Granby Memorial Middle School
Low-Slope Roof Replacement
321 Salmon Brook Street
Granby, CT

ADDENDUM NUMBER 4

June 24, 2020
Page 1 of 1

REVISED SECTION DETAIL @ ROOF ACCESS STRUCTURE

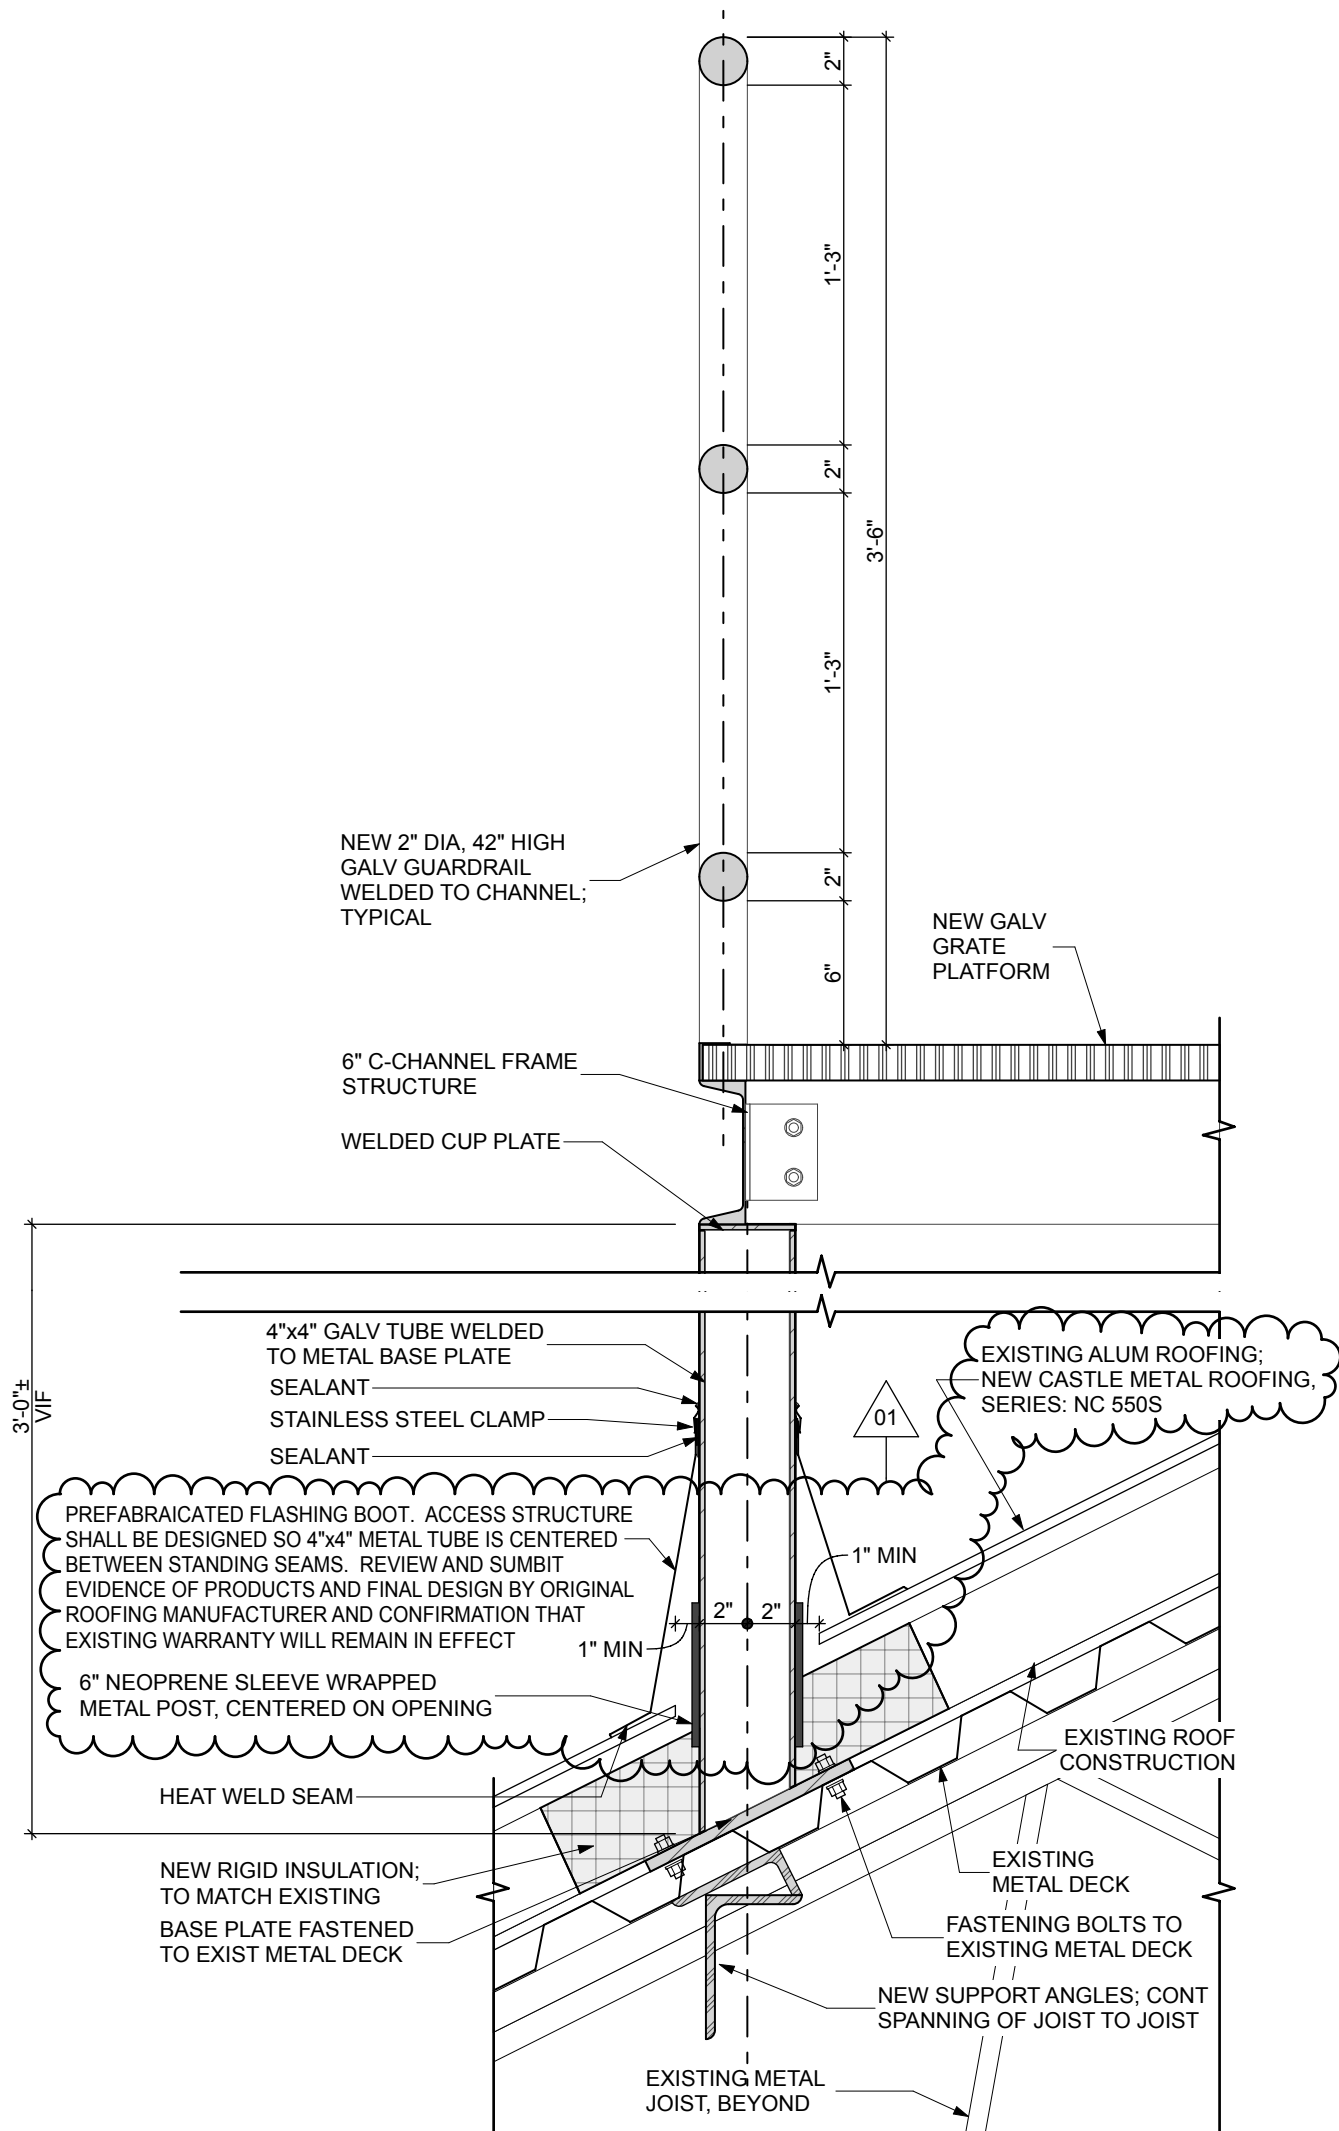
5. Detail C1/A-302 is revised per attached sketch SKA-01: existing standing seam metal roof is aluminum (manufacturer and product are indicated on SKA-01). Owner's Roofing Warranty must remain in full effect via these modifications. Further, Roof Access Structure is indicated to be galvanized steel. To account for dissimilar materials, spatial separation and neoprene sleeve are indicated on the attached sketch SKA-01.

CLARIFICATION OF SEPARATION BETWEEN DIFFERENT MATERIALS
